# Stage 1 Road Safety Audit

Tallaght/Clondalkin to City Centre Core Bus Corridor  
BCIDA – ACM - STY\_ZZ – 0809\_XX\_00 – RP – ZZ – 0001

Client – National Transport Authority  
Stage – Stage 1

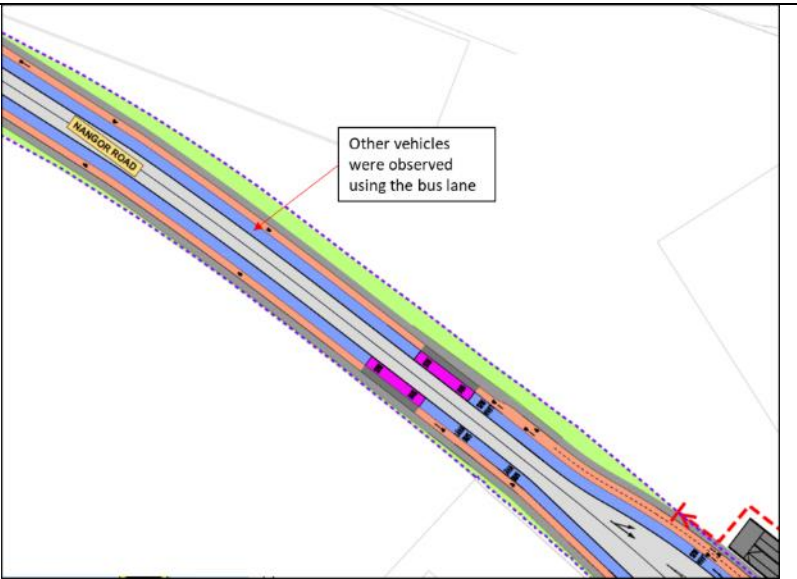
<b>4.3.15 Problem</b>		
<b>Location:</b>	Walkinstown Roundabout	
<b>Drawing:</b>	Sheet 19 of 47	
<b>Summary:</b>	Motorists using link between Greenhills Road and St. Peter's Road	
<b>Description:</b>		<p>The link between St. Peter's Road and Greenhills Road will remain open. It was observed that a relatively high volume of motorists opt to use this link as a rat run rather than negotiate the roundabout and this is likely to continue following the implementation of the scheme. The proposed parking arrangement to the front of the Cherrytree will require motorists to reverse to/from the perpendicular parking spaces onto this link road. This is likely to result in conflicts between vehicles manoeuvring to</p>

or from these spaces and vehicles rat running through the link.

**Recommendation:**  
Measures to discourage rat running should be considered along this link.

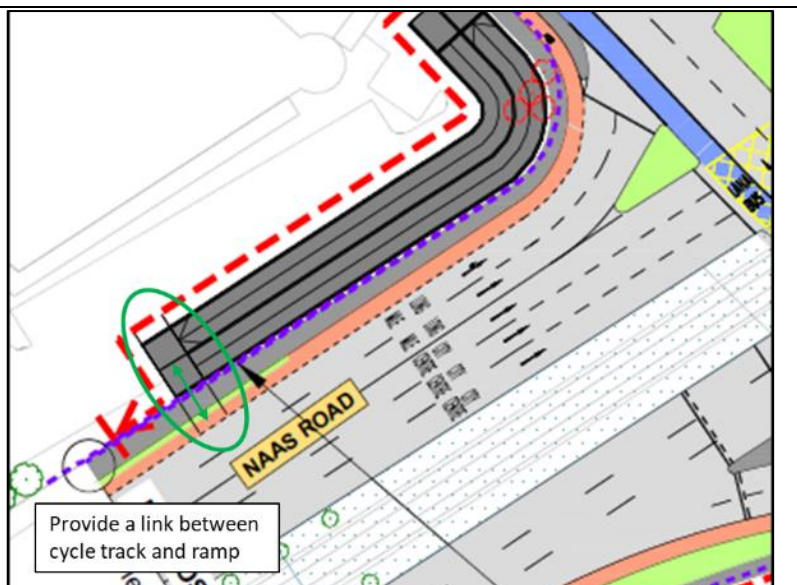
<b>4.3.14 Problem</b>		 <p>Provide a link between cycle track and ramp</p>
<b>Location:</b>	At Nangor Road / Naas Road junction	
<b>Drawing:</b>	Sheet 07 of 12	
<b>Summary:</b>	Access to pedestrian and cycle bridge	
<b>Description:</b>		<p>It is not clear how cyclists on the eastbound cycle track on Naas Road will access the proposed pedestrian and cycle ramp. Failure to provide a safe link between the cycle track and ramp may result in cyclists having to dismount their bicycles in order to cross the grass verge and footpath or collisions between cyclists and pedestrians.</p> <p>If an easy access onto the ramp is not provided, some cyclists may decide to continue on the carriageway thus increasing the risk of collisions with motorists.</p>

<b>Recommendation:</b>		<p>Provide a safe link between the eastbound cycle track on Naas Road and proposed pedestrian/cycle ramp.</p>

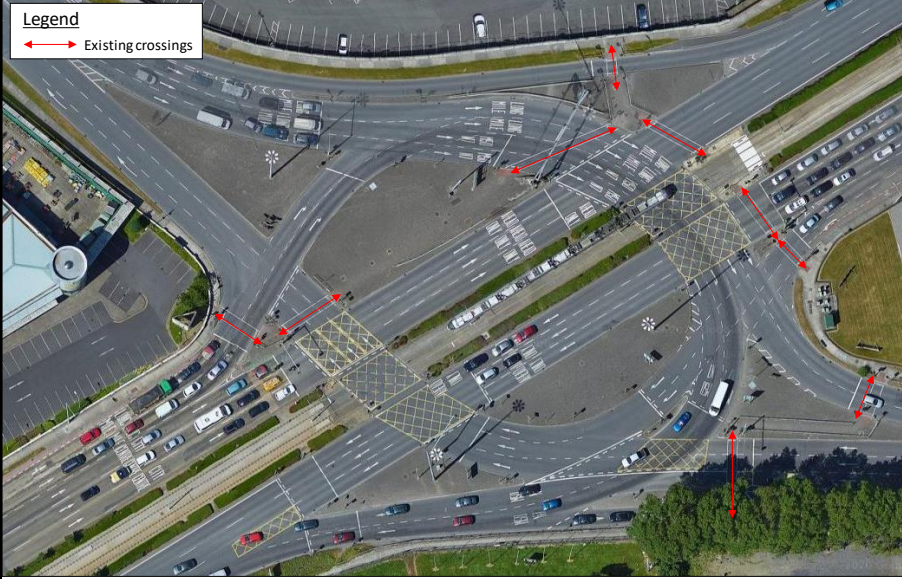
<b>4.3.16 Problem</b>		
<b>Location:</b>	At Nangor Road / Naas Road junction	
<b>Drawing:</b>	Sheet 07 of 12	
<b>Summary:</b>	Removal of pedestrian crossings	
<b>Description:</b>		<p>It is proposed to remove that existing at-grade pedestrian crossings with the installation of the pedestrian and cycle bridge over the junction. However, it is likely that pedestrians and cyclists will continue to cross the road at-grade due largely to shorter travel distances (rather than having to negotiate the ramp and bridge). This is likely to result in collisions.</p>
<b>Recommendation:</b>		<p>The at-grade pedestrian crossings should be retained.</p>

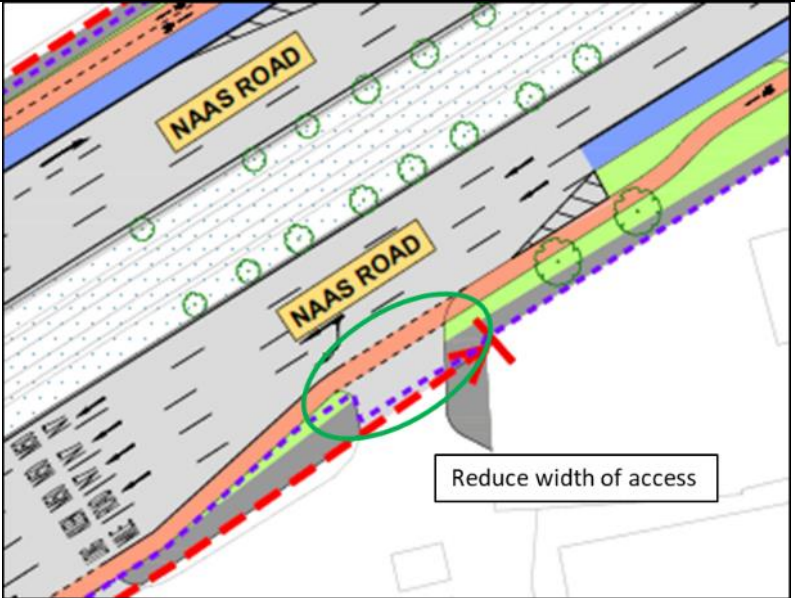
<b>4.3.18 Problem</b>		
<b>Location:</b>	Naas Road	
<b>Drawing:</b>	Sheet 07 of 12	
<b>Summary:</b>	Access to Beechlawn Motors encourages fast speeds

<b>Description:</b>		<p>The orientation and width of the access to Beechlawn Motors from the southwest bound carriageway encourages motorists to enter the access at high speeds. This may result in collision with cyclists on the cycle track or pedestrians on the footpath.</p>
<b>Recommendation:</b>		<p>The width of the access should be reduced to reduce the speed of vehicles at they turn into Beechlawn Motors.</p>

pedestrians and cyclists.		
4.3.18	yes	yes		Design revised with bus lane and cycle track kerb upstand now provided across access.	
4.3.20	no	no	Kerb vertical separation is provided between bus lane and cycle track		Yes

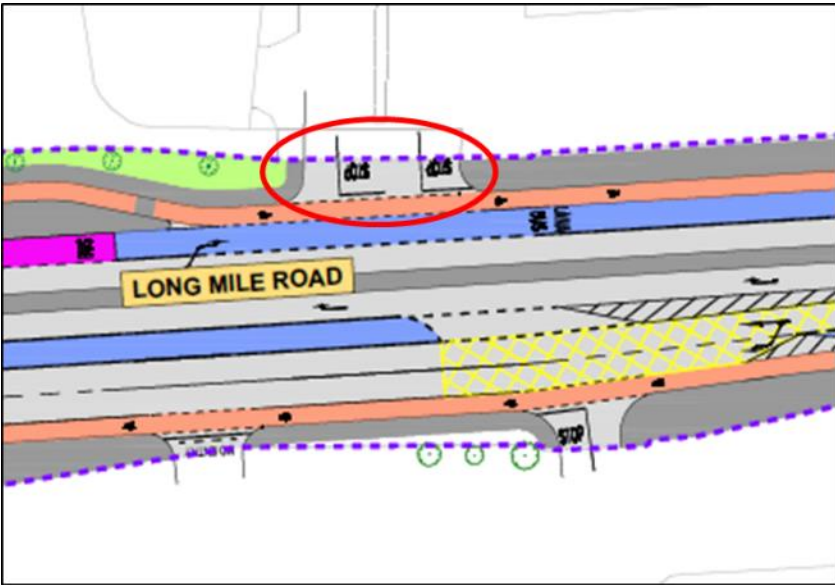
<p><b>4.3.28 Problem</b></p>	
<p><i>Location:</i></p>	<p>Walkinstown Avenue</p>
<p><i>Drawing:</i></p>	<p>Sheet 09 of 12</p>
<p><i>Summary:</i></p>	<p>Footpath discontinued across access points</p>

The footpath along the east side of Walkinstown Avenue should be continued across the junction to ensure pedestrians have priority. Failure to provide a footpath across the accesses would give motorists priority and therefore increase the risk of collisions with pedestrians.

The footpaths should be continued across the accesses on Walkinstown Avenue.

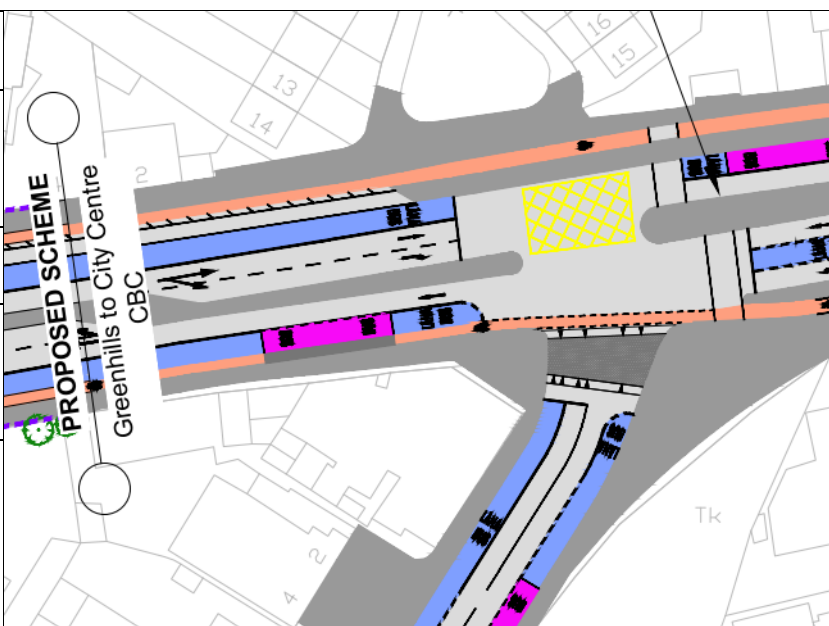
<p><b>4.3.40 Problem</b></p>	
<p><b>Location:</b></p>	<p>Drimnagh Castle Primary School</p>
<p><b>Drawing:</b></p>	<p>Sheet 10 of 12</p>
<p><b>Summary:</b></p>	<p>Indiscriminate parking on the Long Mile Road in proximity to the school</p>
<div style="display: flex; justify-content: space-around;"> <div style="width: 45%;">  </div> <div style="width: 45%;">  </div> </div>	
<p><b>Description:</b></p> <p>On-street parking on Long Mile Road at Drimnagh Castle Primary School was observed. Vehicle parking at this location would obstruct both cyclists and buses on the new scheme. Buses and cyclists would be required to deviate suddenly from their designated lanes possibly resulting in conflicts with traffic on the main east bound lane.</p> <p>Furthermore, parked vehicles are likely to obscure visibility between approaching eastbound traffic and pedestrians crossing at the Toucan Crossing. This may result in collisions between motorists and pedestrians.</p>

<p><b>Recommendation:</b></p> <p>Parking enforcement measure should be implemented to prevent motorists from parking on the Long Mile Road adjacent to the school.</p>

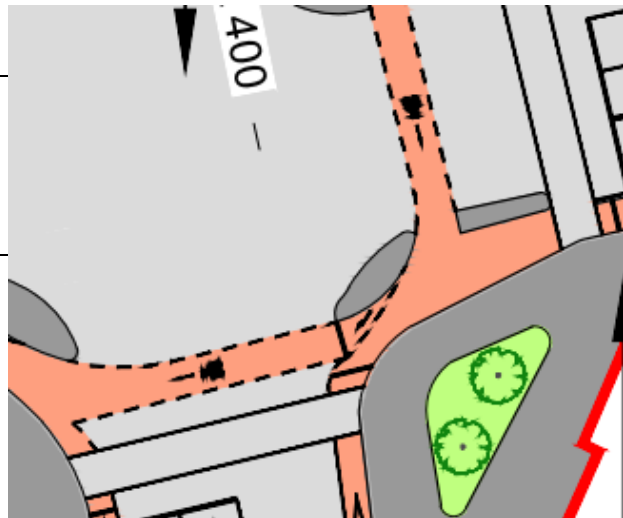
The proposals are to provide a variety of crossing types and shared areas across the scheme. It is necessary to ensure that the appropriate tactile paving is provided at these locations to ensure that pedestrians, particularly the vision impaired, are aware that they are entering a shared space or using a controlled / uncontrolled crossing. Should incorrect or no tactile paving be provided this could result in these users unknowingly walking into the carriageway resulting in a vehicle pedestrian collision or a cycle track and being struck by a cyclist.

Ensure appropriate tactile paving is provided across the scheme in accordance with the 'Guidance on the Use of Tactile Paving Surfaces'.

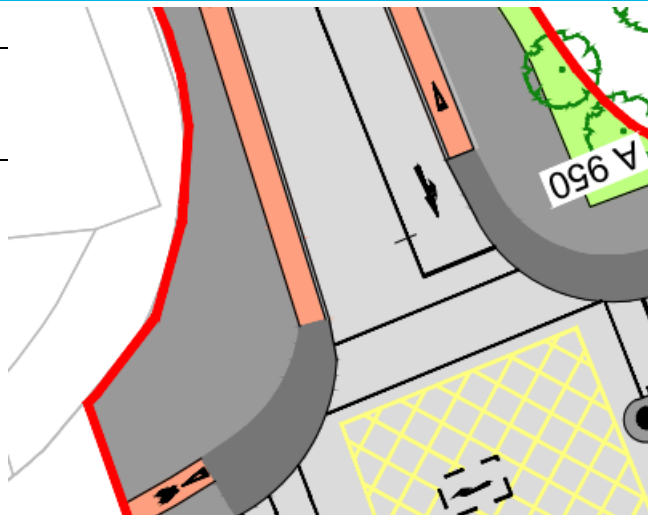
The scheme proposes to provide dedicated cycle facilities and remove cycle traffic from the mainline flow of traffic. It is unclear if there is sufficient stacking capacity, at some locations, for cyclists intending to turn right at the corners of the junctions, as illustrated in the extract above on the southeast corner of Belgard Square North/Belgard Square West. If sufficient stacking capacity or sufficient width are not provided at these locations, this could result in instances where cyclists that are waiting to turn right are struck by passing cyclists or cyclists that are continuing straight through could collide with the kerb.

Ensure adequate stacking capacity and cycle track width is provided at these locations.

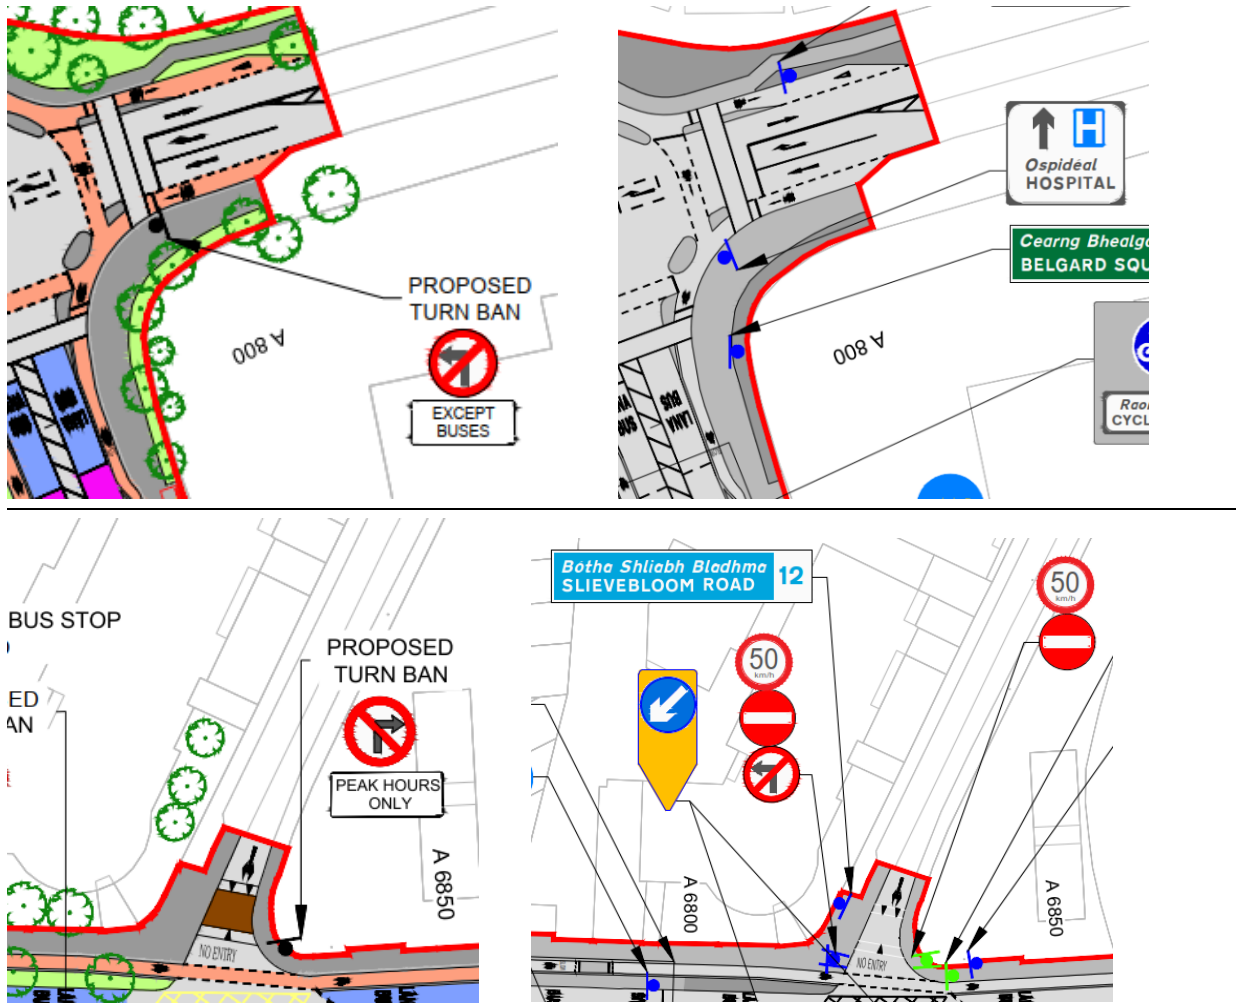
If no tactile paving is provided in an advance of the shared use area and advance of cycle lanes from a shared area, cyclists may not be aware that it is a shared use area, which can lead to cyclists colliding with pedestrians resulting in pedestrian and cyclist falls, or the visually impaired may enter into the cycle lane and onto the carriageway.

Appropriate tactile paving should be installed at the start and end of all cycle lanes where shared use is proposed throughout the scheme.

5.1.3	yes	yes		This will be addressed at detailed design stage	
5.1.4	yes	yes		GAs show the turn bans only. Signs drawings show all the signs. Consistency has been checked

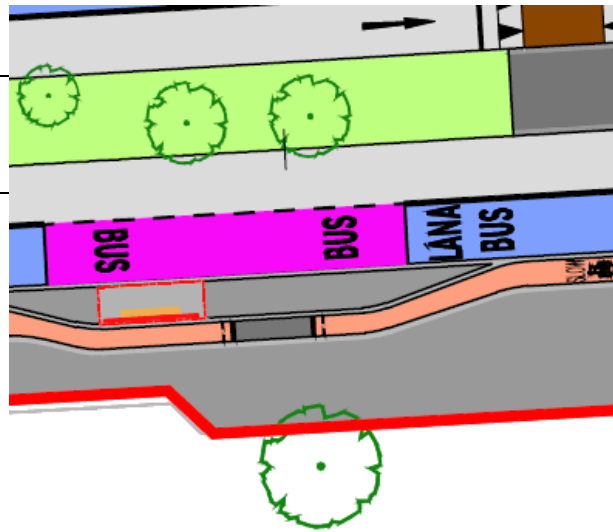
It is noted that there are several inconsistencies between the separate drawing series. For example, as shown above on the westbound approach on the Belgard Square North Road to the junction with the Belgard Square East, when comparing the General Arrangement drawing to the Traffic Signs & Road Marking drawing, the signage is different for each drawing. Inconsistencies in layout arrangement on construction drawings can lead to appropriate signage not being provided which could result in driver confusion or taking inappropriate manoeuvres which could lead to collisions.

Ensure the proposed signage is consistent across all proposed drawing series.

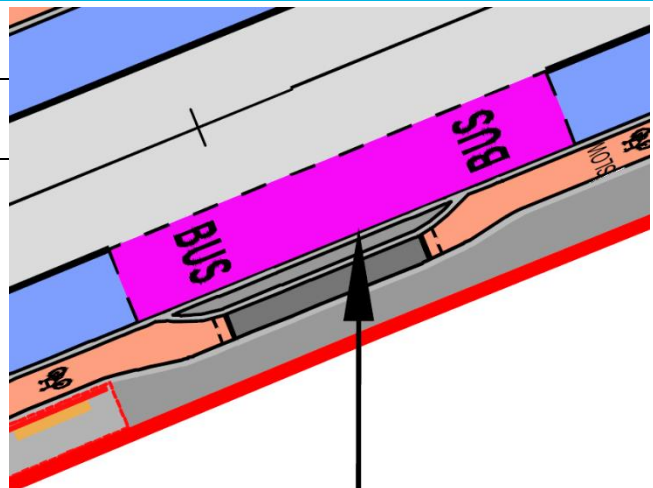
It is proposed to provide raised shared surfaces at the bus stops located along the route of the cycle tracks / lanes to facilitate pedestrian access from the footpath to the floating bus islands. On approach to these shared surfaces, it is noted that no yield, arrow or cycle symbol are indicated on the cycle lanes. These road markings inform cyclists that they are entering a shared space and may be required to yield to pedestrians. A lack of these road markings could lead to cyclists failing to yield resulting in a pedestrian cyclist collision at these locations.

Road markings should be provided in accordance with the 'National Cycle Manual'.

5.1.5	yes	yes		Marking not shown on GAs but markings as per PDGB will be provided	
5.1.6	yes	yes		Shared bus stop landing areas have been revised and widened to a minimum of 1m where practicable as per PDGB.

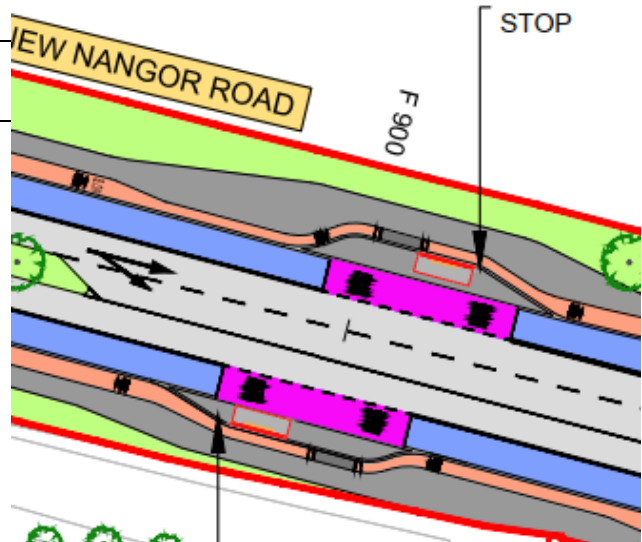
Ensure that there is adequate width on all segregation islands at bus stops, particularly in the locations of the bus doors, to facilitate adequate space for boarding and alighting bus passengers.

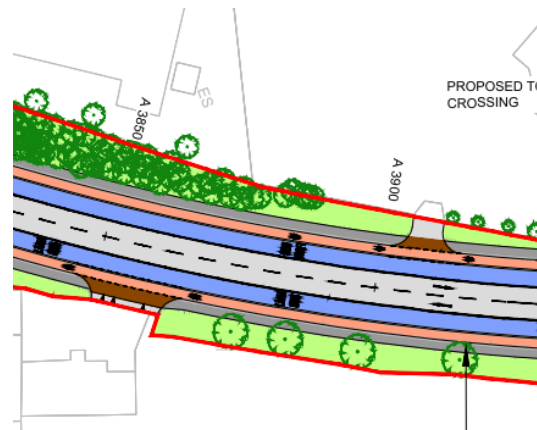
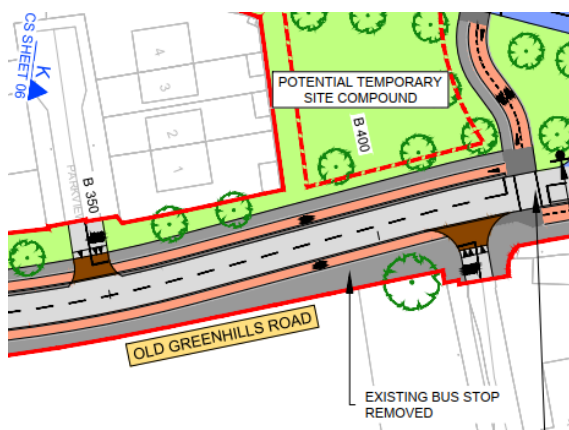
It is recommended that swept path analysis is undertaken on the proposed layouts using different types of bicycles and that the design is appropriately amended, if required.

5.1.7	yes	yes		Layouts as per PDGB have been checked for appropriate swept path	
5.1.8	no	no		Raised table arrangements provide different layouts depending on location and presence of adjacent bus lane where BusConnects detail is used.	Yes

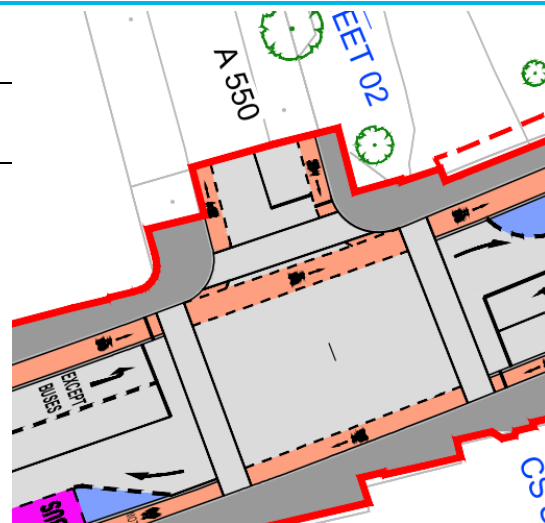
Provide advance direction and warning signage to inform drivers of a restriction to through traffic southbound on Belgard Square West.

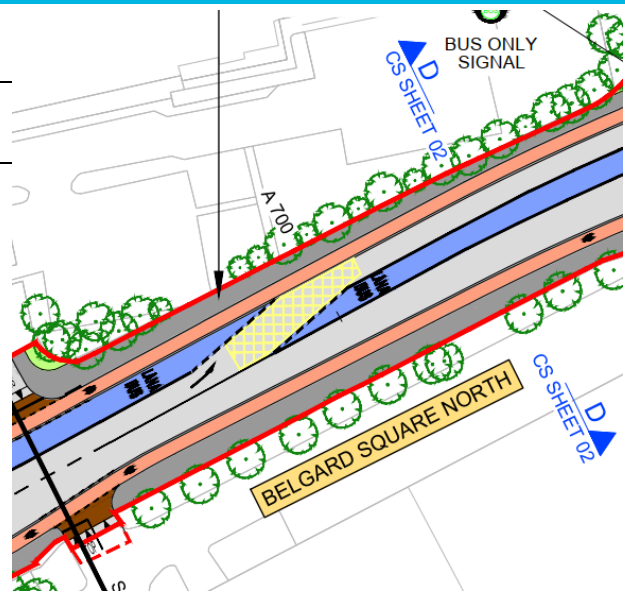
Provide an advanced stop line for cyclists on the side road.

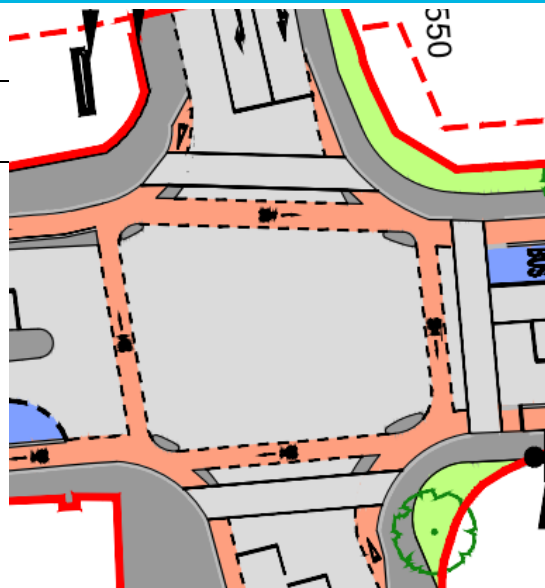
The design should ensure that sufficient green time is provided for pedestrians to cross in a single movement. Flashing amber phases should not be included as this may encourage motorists to move forward while vulnerable NMUs are still on the carriageway.

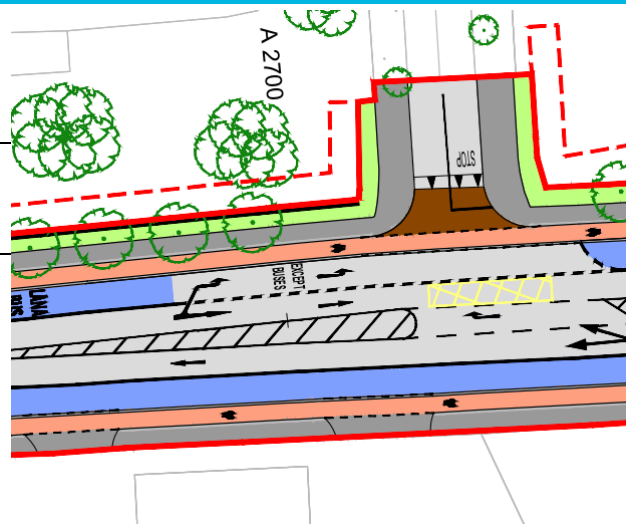
Ensure adequate cycle stacking space and capacity and width of cycle track is provided at this location.

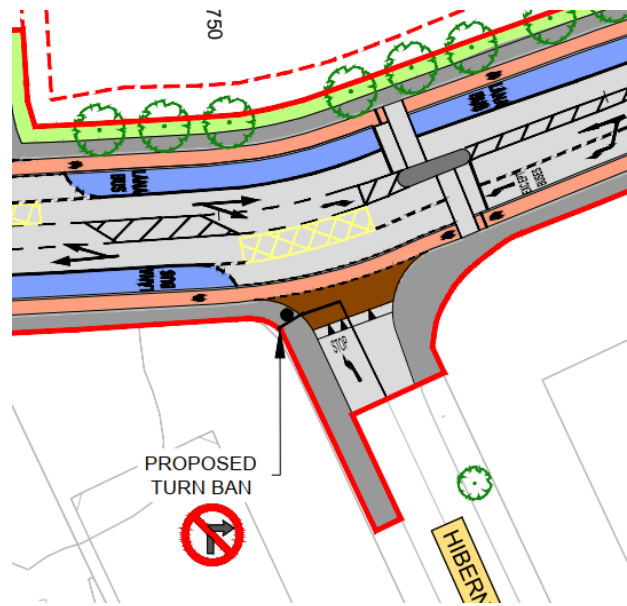
Ensure all road markings and signage are clear and unambiguous to all road users.

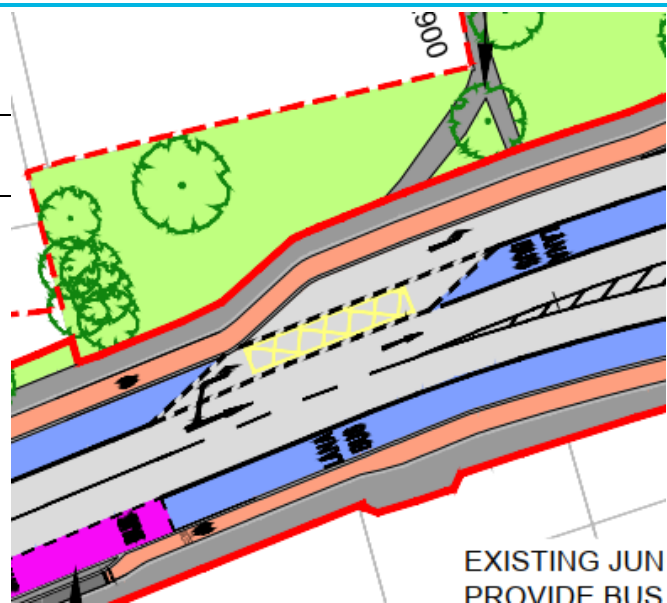
Extend the pedestrian splitter island, on the eastern side of the junction, westwards towards the end of the hatching in front of the right turn lane on Greenhill Road.
